ADDENDUM NO. 1

Reference: Camp Williams ó Building 2500 UTES Addition
Utah National Guard - Draper, Utah

Project No.10180480

Addendum No. 1

AE201
 SHEET 10 OF 16

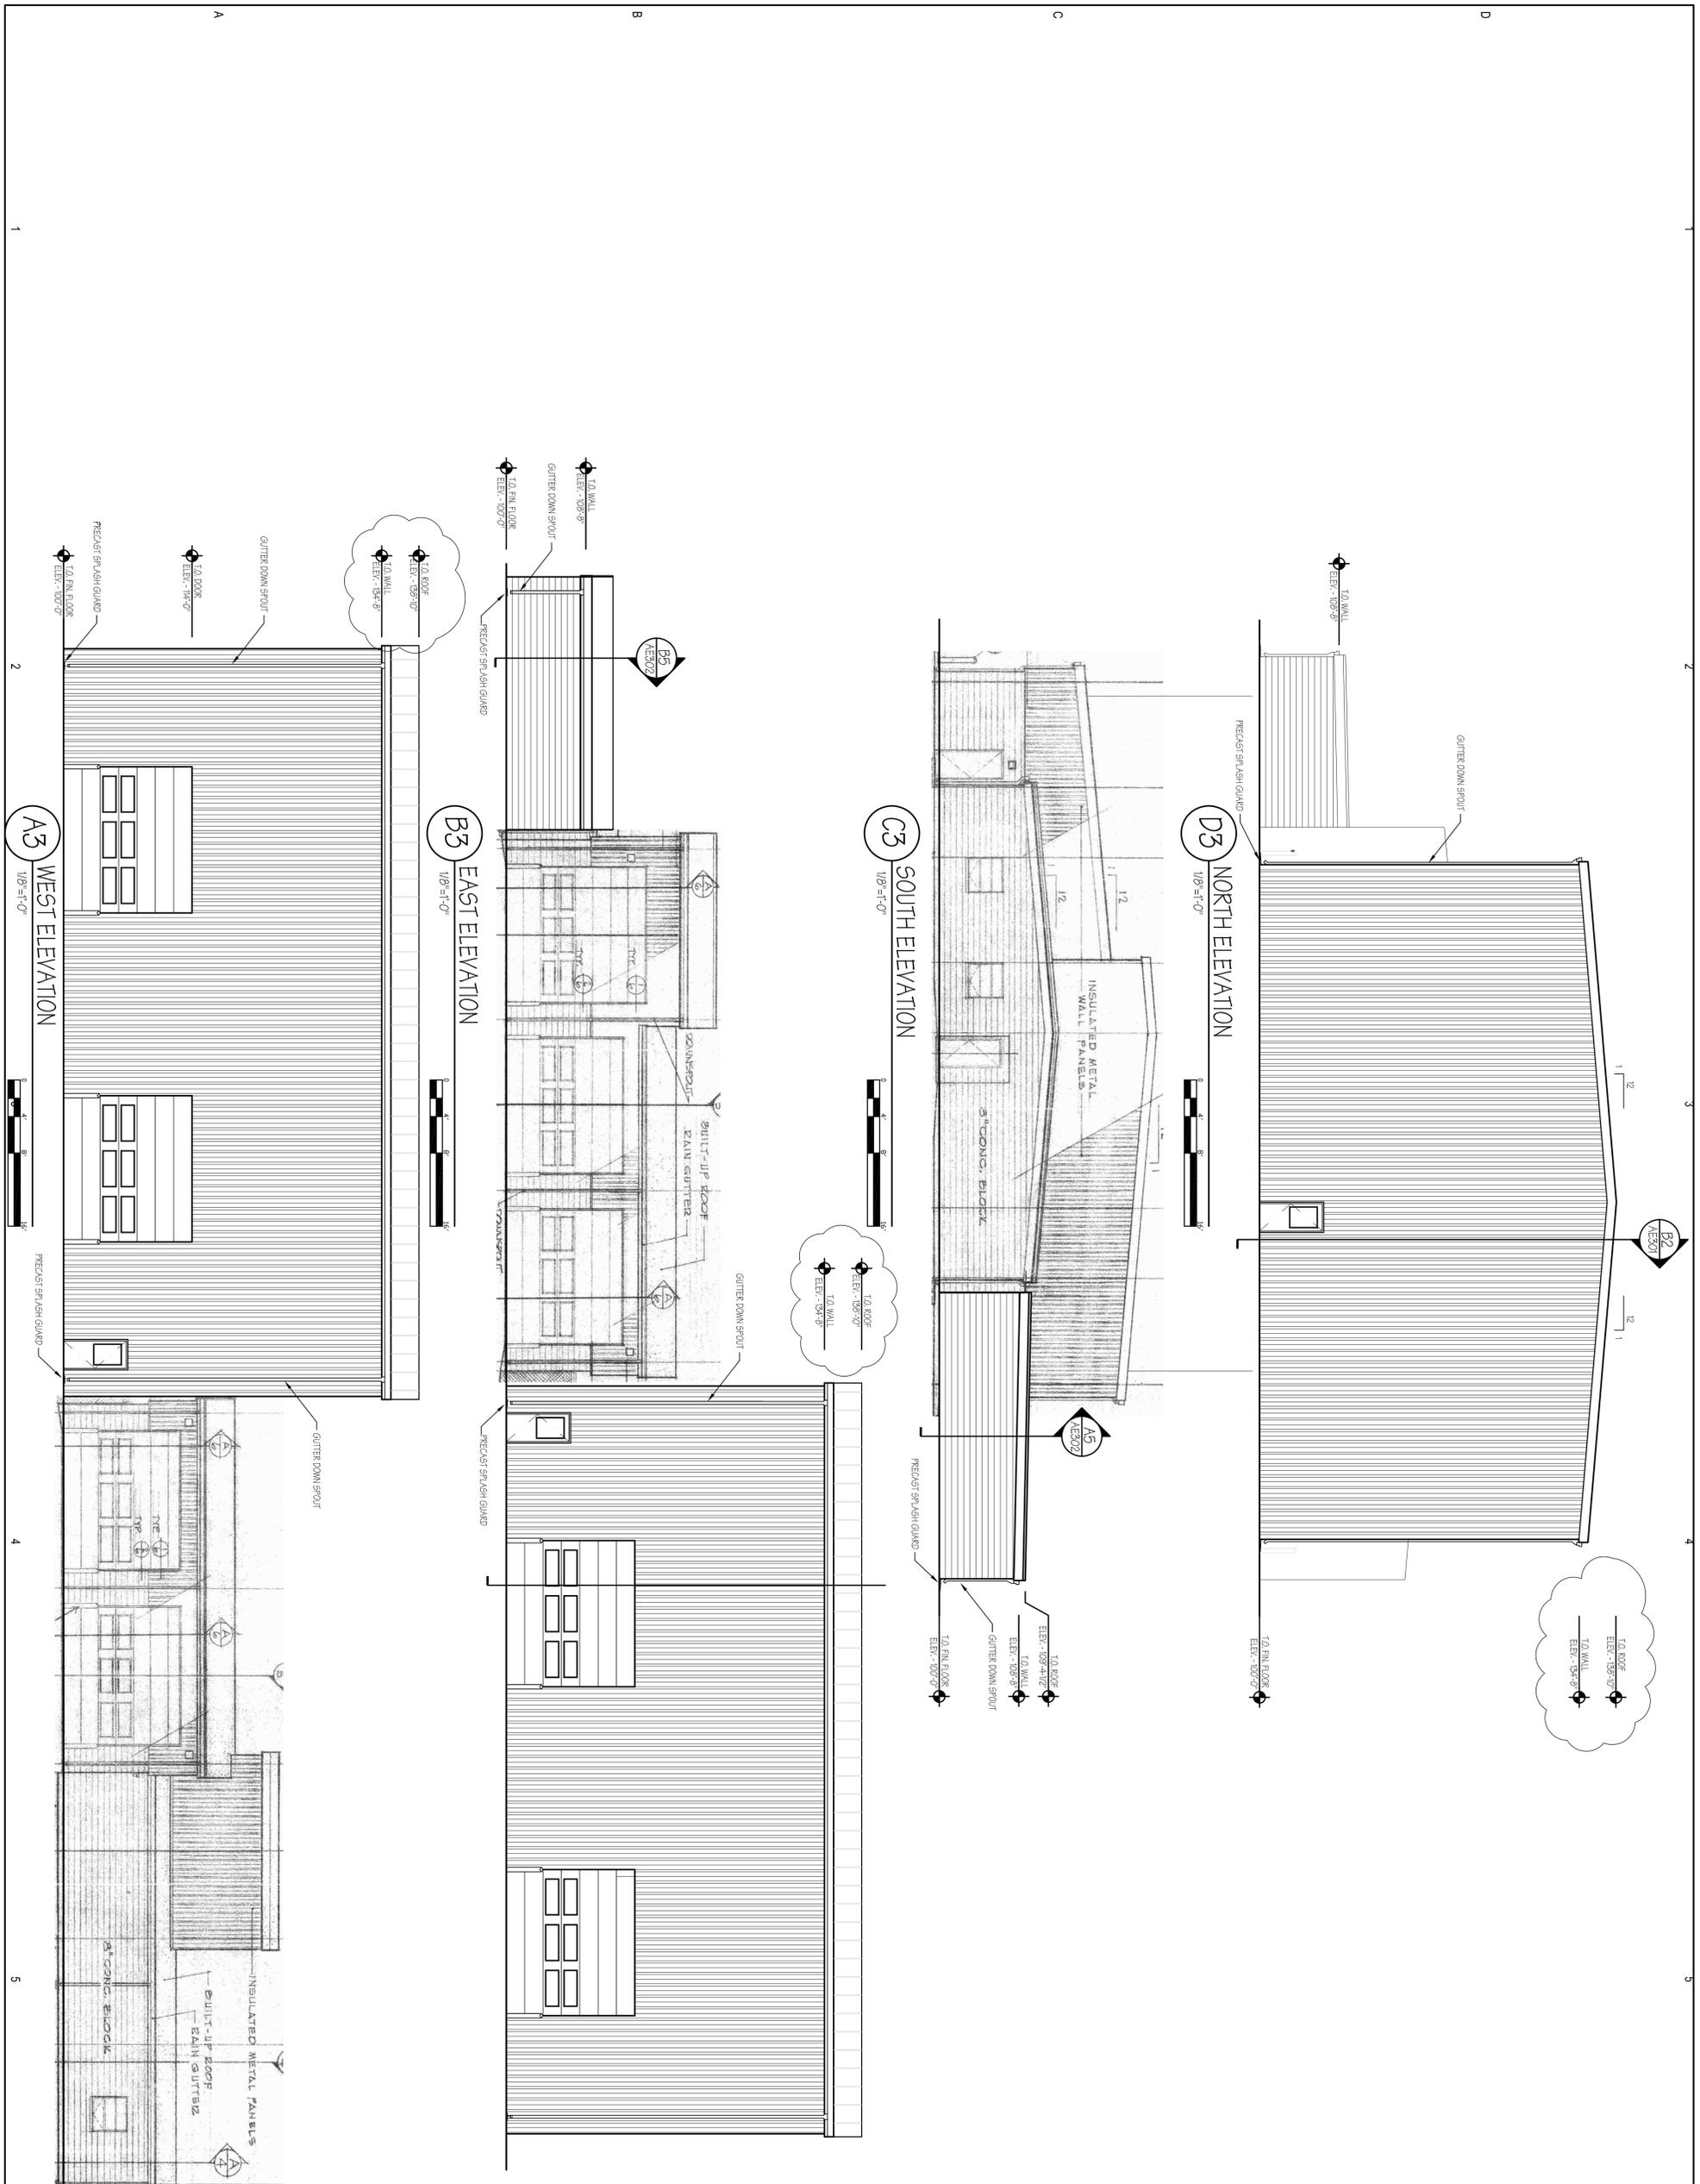
1 -26 5 sheet s Revised Architectural Sheets AS102, AE120, AE201, AE301, AE302.

P201
 SHEET 2 OF 13

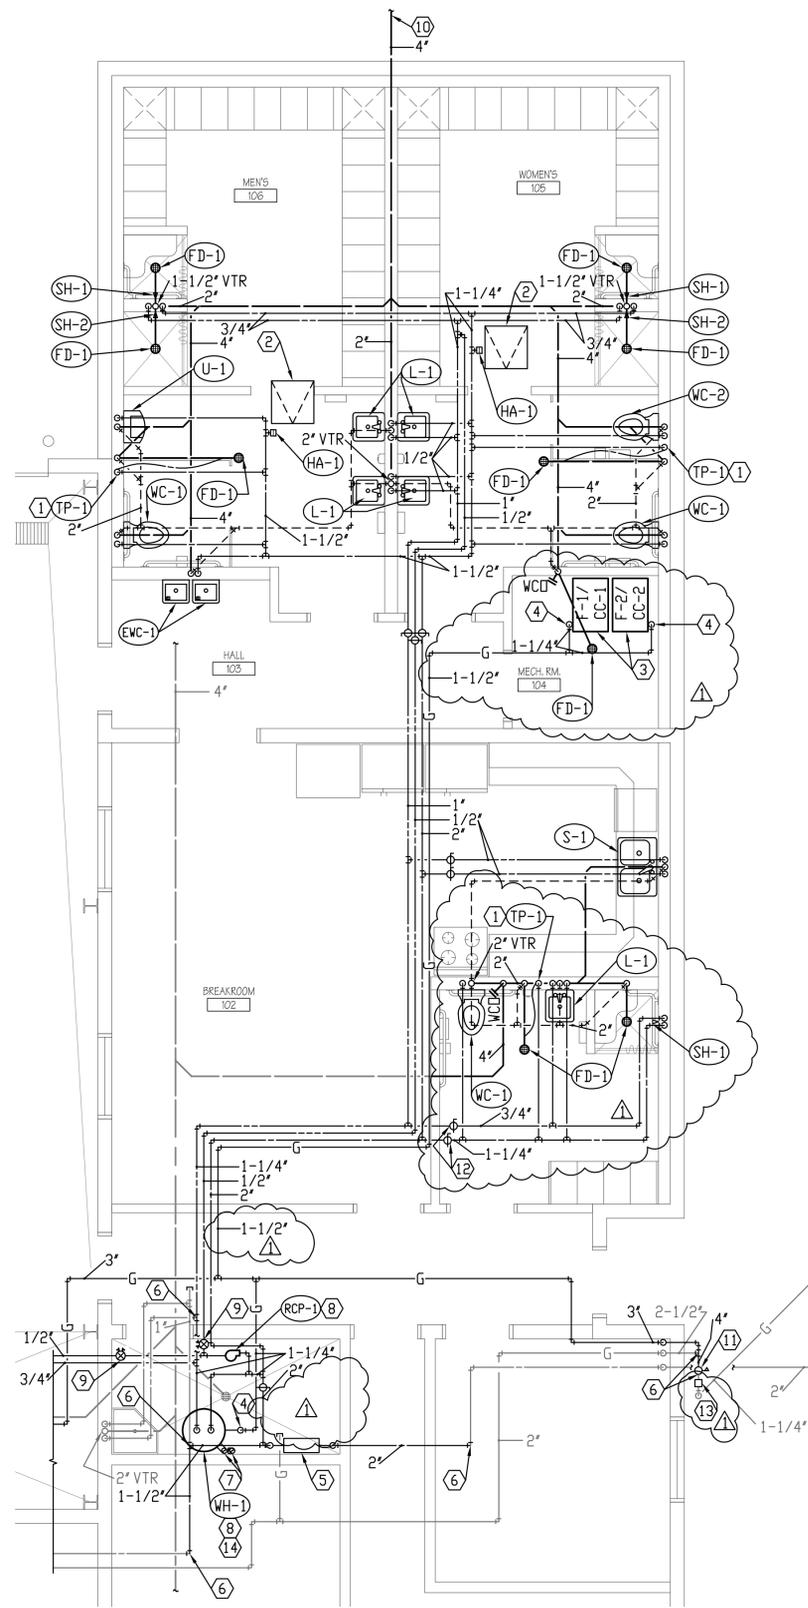
- B. Drawings:
- 1. Replace the following sheets with the attached revised sheets: P201, P401, P601, M101, M201, M401, M502, M601, M602 and ME101.
 - 2. Sheet AS100 and P401: As bid alternate #1, replace the 2-inch diameter domestic water line from the PRV station in the water heater room to the main line on the south side of the building (approximately 25 feet inside building and 115 feet outside the building). The section of pipe inside the building is located above the ceiling until it reaches the outside wall at which point it drops below grade. Remove and replace the ceiling as needed to access the pipe and match the ceiling finish to existing.
